UT to Magness Creek Mitigation Project

Year 1 (2023) Monitoring Report FINAL

Response to DMS Comments (January 4, 2024) for DRAFT Monitoring Year1 Report.
UT to Magness Creek
Broad River Basin: 03050105
DMS Project #100081 DEQ Contract #7604

Subject: Response to IRT Comments based on their review of the MY0/ As-Built Baseline Report and Record Drawing. UT to Magness Creek Mitigation Project; Cleveland County, NC
Broad River Basin: 03050105; DMS Project #100081

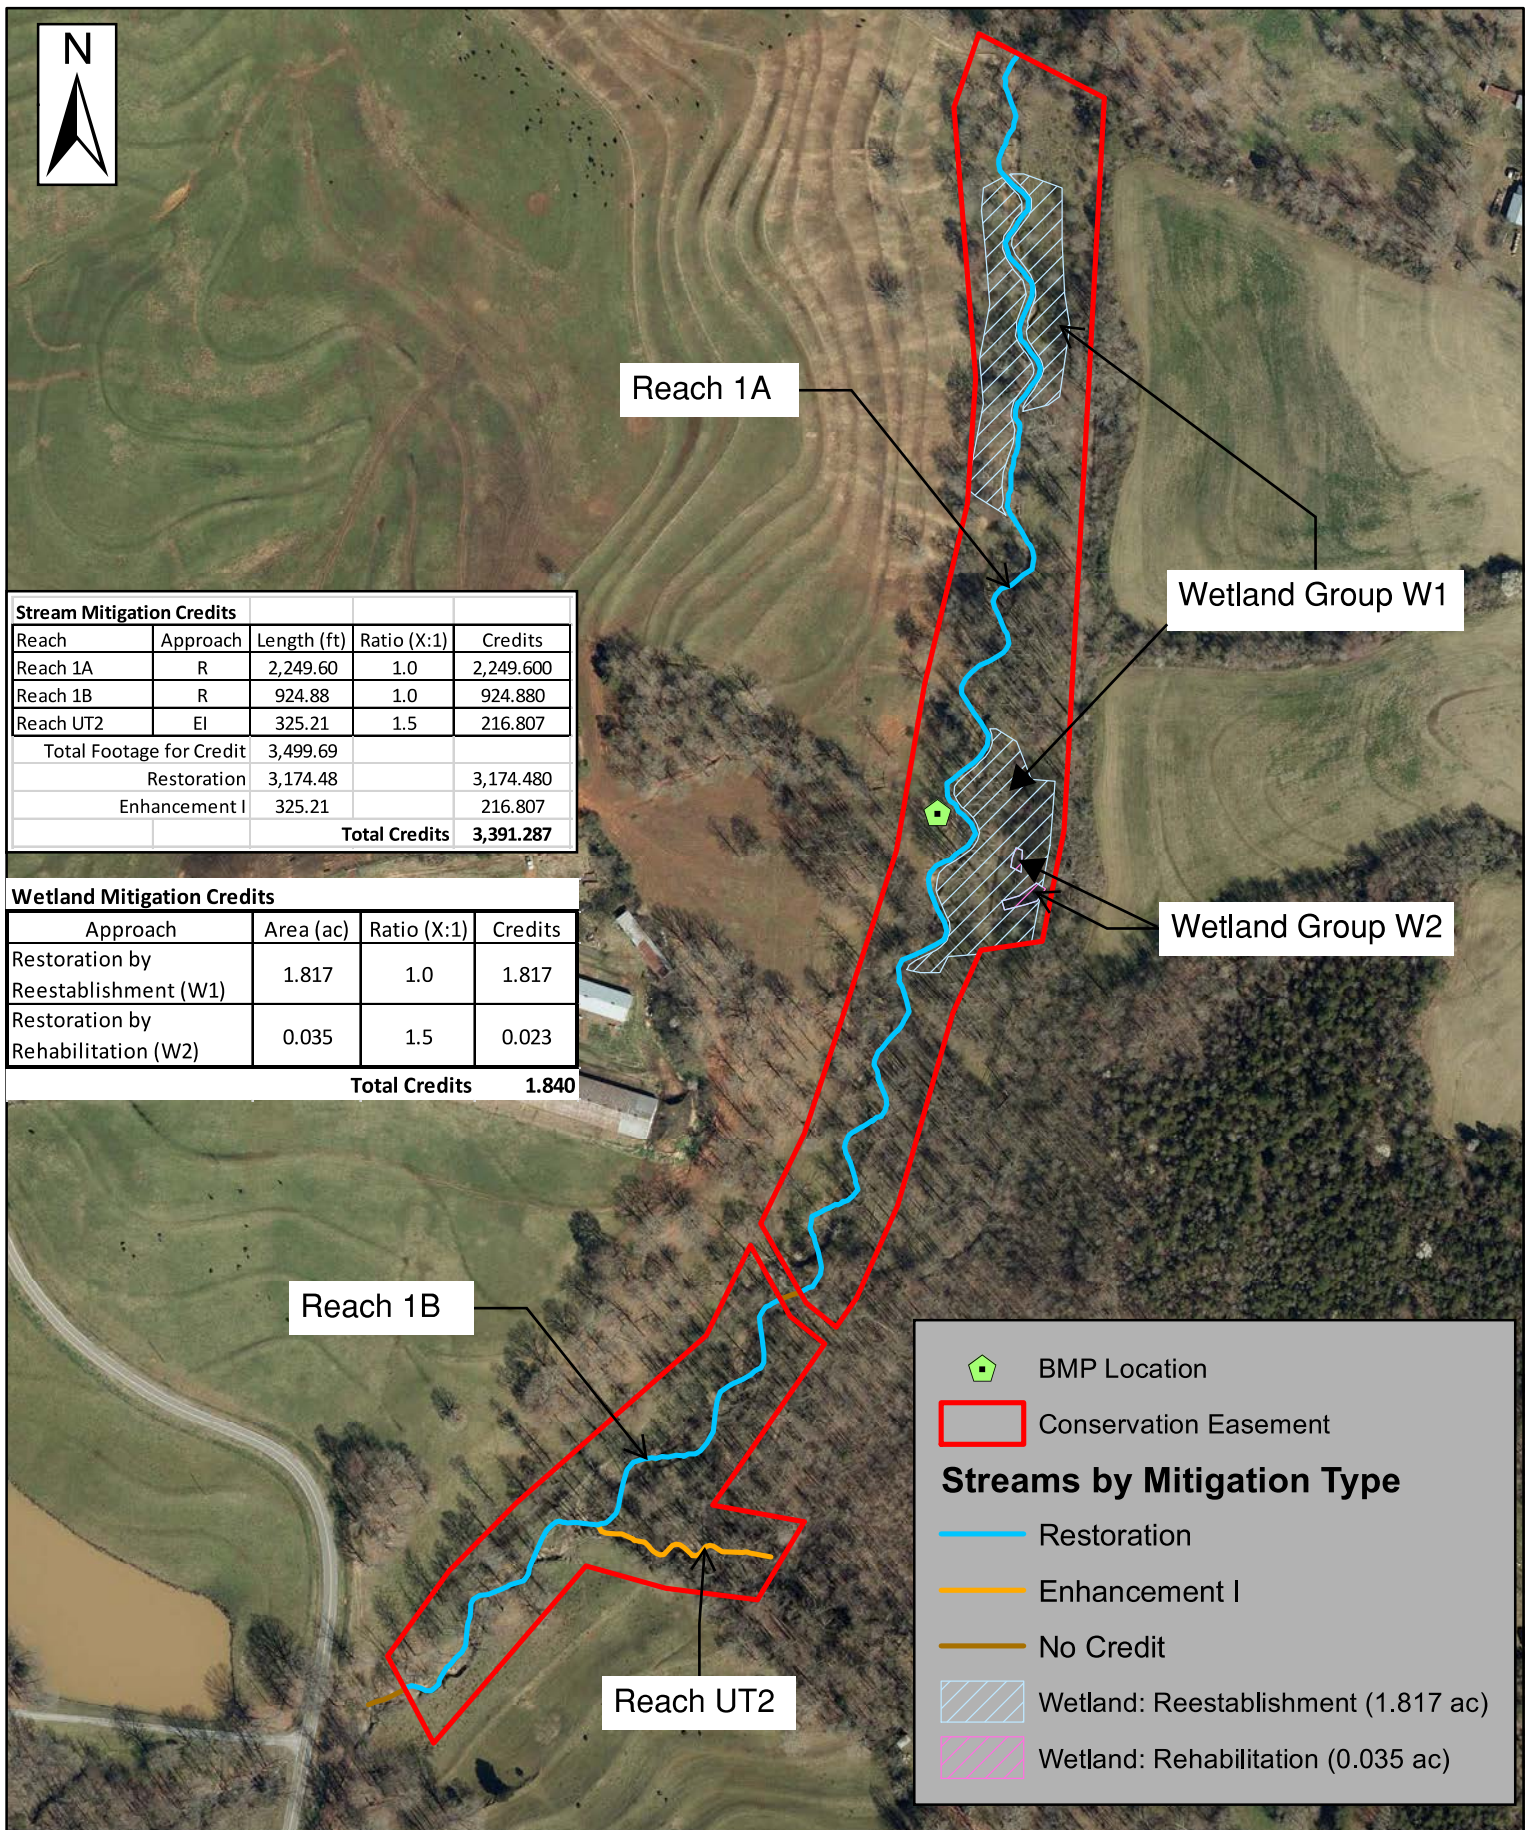
Figure 2 – Project Asset Map: Please label the reaches and wetland areas as shown in the figure credit table & Table 1. Project Mitigation Quantities and Credits.

RESPONSE: Labels have been added to the reaches and wetland areas as shown on the Project Asset Map as shown in the figure credit table and Table 1 as requested.

Overview Map: Current Condition
Plan View (CCPV)
UT to Magness Creek Mitigation Project
Cleveland County, NC

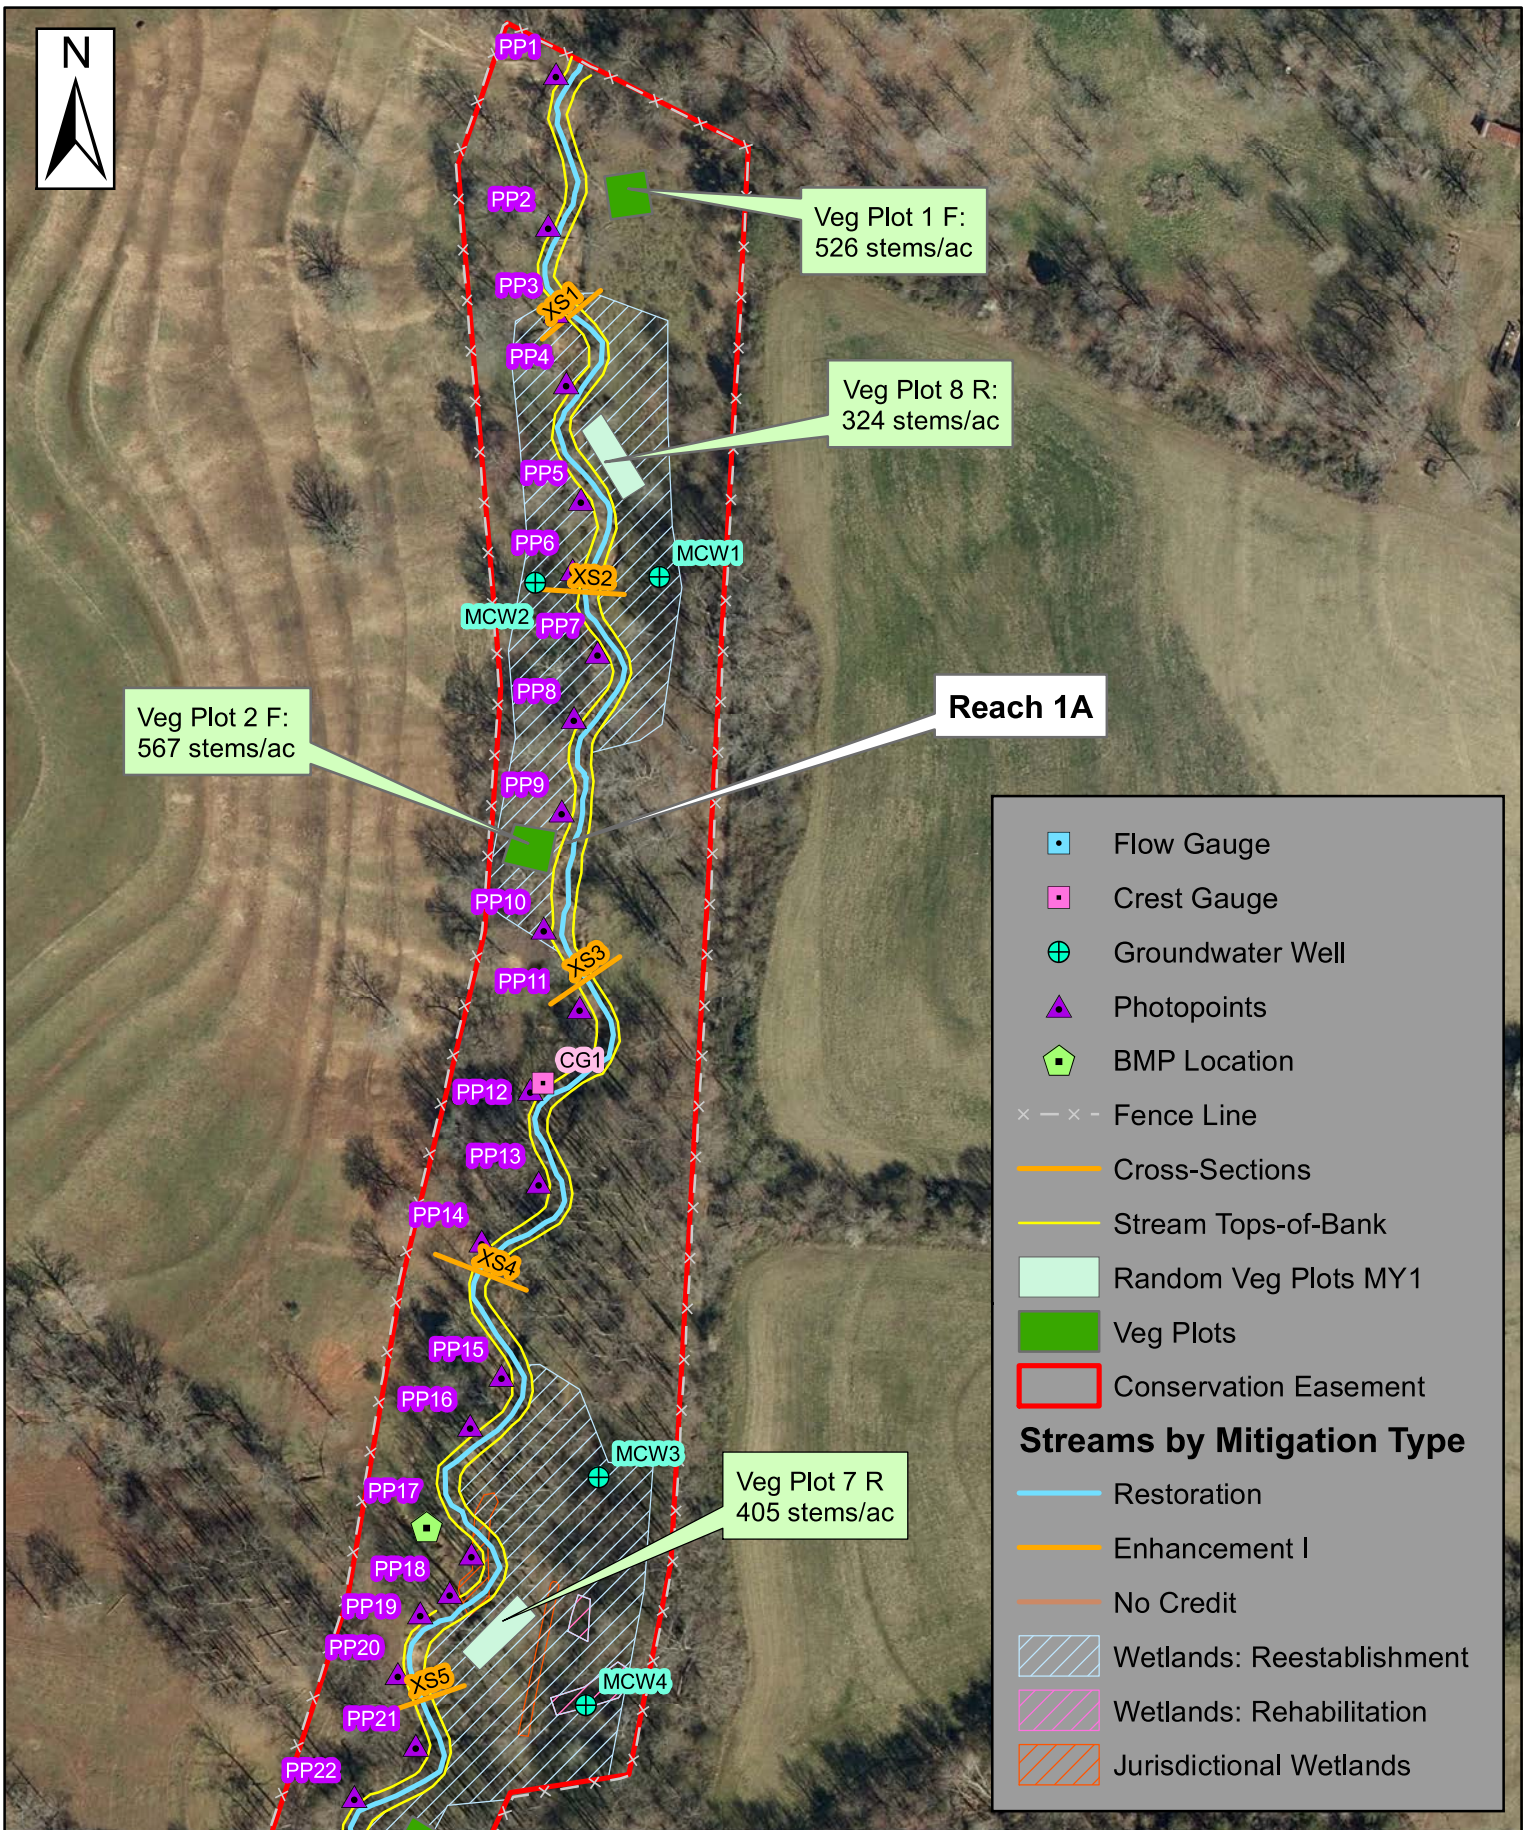
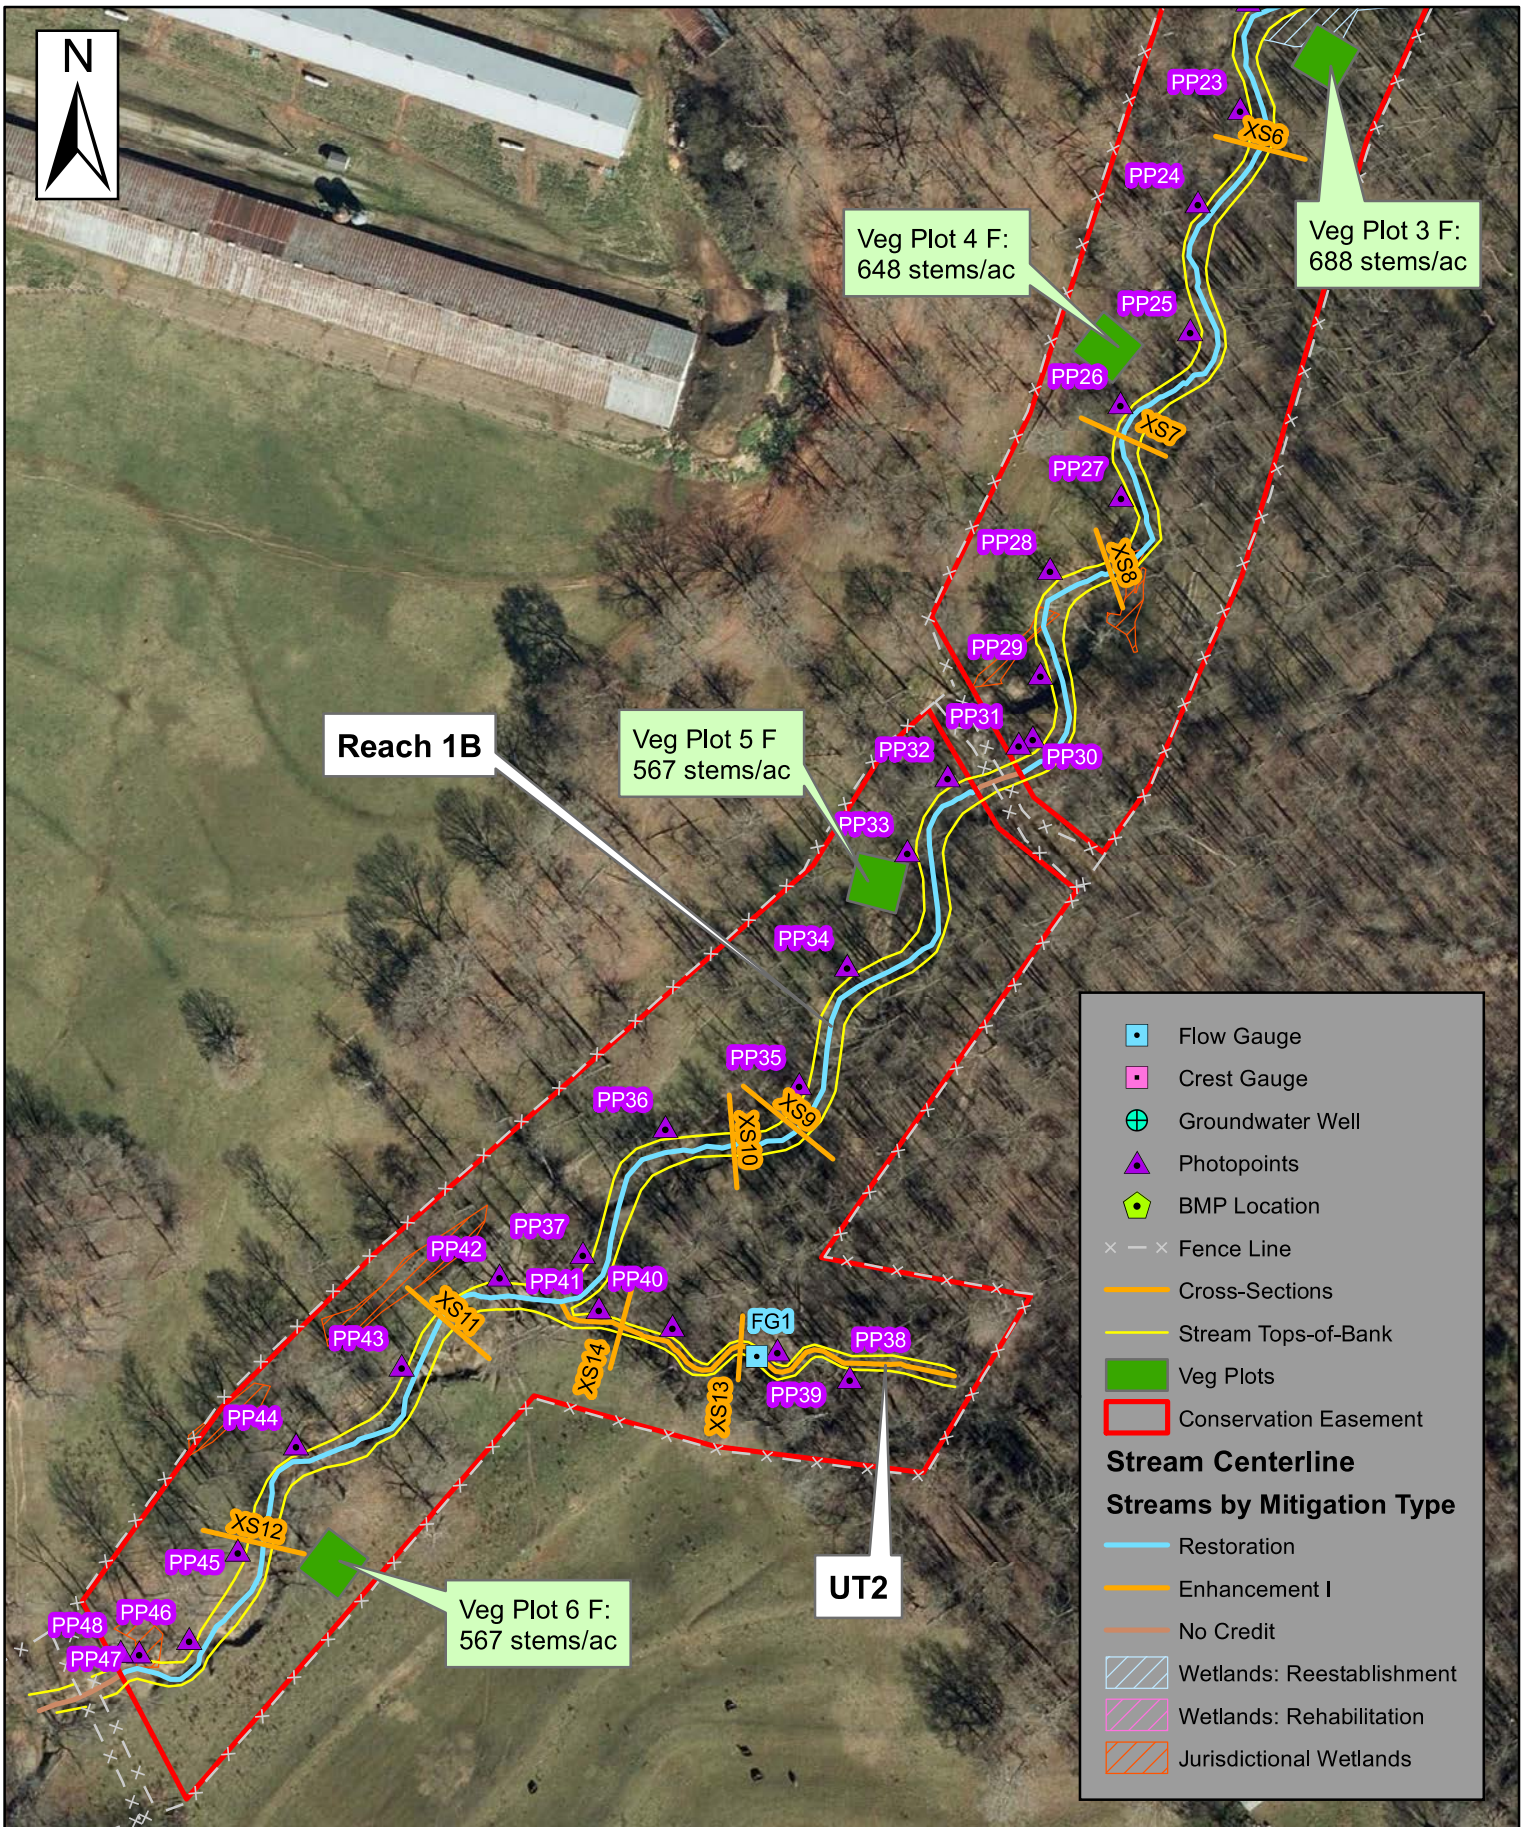
CCPV Maps: The CCPV map title boxes should indicate the monitoring year. Please update accordingly.

3. Figure 3 CCPV – Several monitoring stations were relocated from the approved mitigation plan monitoring figure 11 locations. While it is anticipated that some gauges and veg plots may be slightly shifted (a few feet) in the field, we expect the general locations of monitoring stations to align with the mitigation plan figure that was reviewed, commented on, and approved by the IRT. Justifications need to be provided for any major monitoring station changes (e.g., bedrock encountered, change in planted area).

- a. Planted wetland reestablishment credit areas must demonstrate that they meet the vegetation performance standard; please relocate veg plot 3 completely within wetland reestablishment credit area as shown on the approved mitigation plan monitoring figure 11.

- c. DWR made a mitigation plan comment (#6) requesting shifts in the groundwater well locations in the southeast reestablishment wetland. The upper well was relocated closer to the credit area boundary as per USACE and DWR request. But the lower well (MCW4) was installed a distance from the stream and overlapping a rehabilitation area rather than closer to the stream channel as per DWR request. Please explain why the DWR request was not met.

RESPONSE: The monitoring year has been added to the CCPV map title boxes as requested.

RESPONSE: The location of veg plot 3 is located south of where it is shown in the approved mitigation plan monitoring figure 11. The proposed location is dominated by several mature poplar trees in the wetland reestablishment area and the proposed location of the veg plot. Bare root stems are planted among the mature poplar trees; however, a judgement was made in the field to not include the tall and mature stems in a veg plot. The present location of veg plot 3 is more representative of the planted wetland floodplain area than the proposed location and exhibits wetland hydrology and plant species despite being partially located outside of the mapped reestablishment area.

RESPONSE: The MY1 report will include data from MCW4 in its current location. Following the end of the growing season in 2023, MCW4 will be moved closer to the stream channel as requested. Data from the new location will be reported starting in MY2.

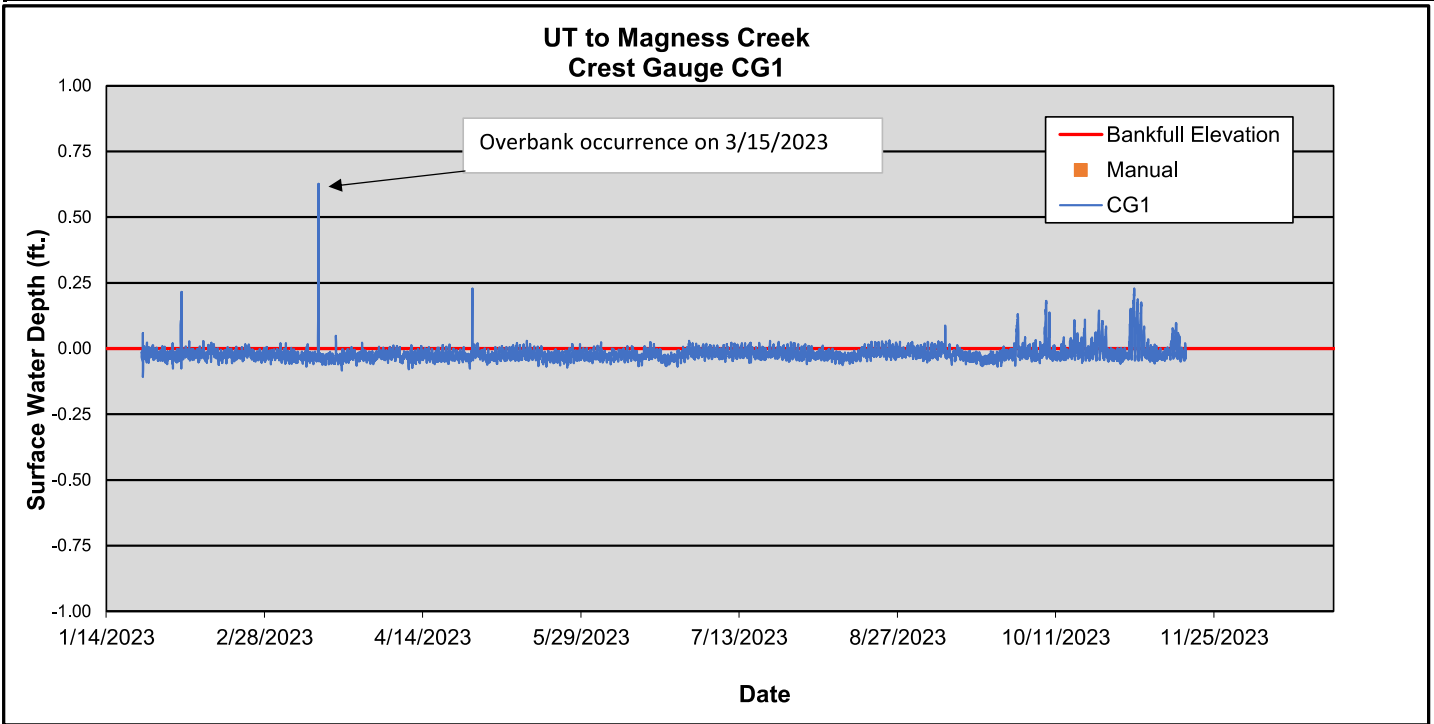
Table 10 & Crest Gauge CG1: As discussed previously, please review, and confirm that the project’s crest gauge has been installed so the corresponding monitoring graph will show the thalweg, water/ pressure line, and established bankfull elevation data to accurately show when flow events reach the bankfull stage elevation. Please review and confirm that the graphs and data presented are accurate. It is difficult to determine how the provided crest gauge data correlates with the provided rainfall data. In addition, numerous water/ pressure line spikes are shown above the “Bankfull Elevation” line; however, only one (1) bankfull event is reported. As currently presented, the graph and data do not appear correct.

RESPONSE: During MY1, the crest gauge was located on the right floodplain with the logger sitting at bankfull elevation. Water pressure spikes above the bankfull elevation line represent changes in barometric pressure and in some cases perched water on the floodplain; however, the event reported on 3/15/2023 represents enough of a spike at 0.62 feet to indicate an over bank event more significant than a perched water scenario. In January 2024 the crest gauge was moved to instream and future monitoring report graphs will include the stream bed elevation, water pressure line, and the bankfull elevation line as requested.
